Route 5 Corridor Study

Planning Commission Work Session
August 9, 2018

Design Guidelines – Sub Area 2: Parking may be placed in front of a building only if architectural treatment and the main entrance faces Route 5, and landscape screening measures for parking are used.

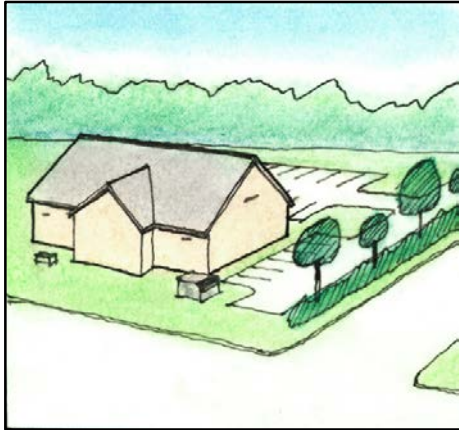
Citizen Comment: Prohibit parking in the front of buildings.

Staff Response: Recommend no change; Limited parking in the front of buildings could be supported if addressed through architectural treatment and landscaping.
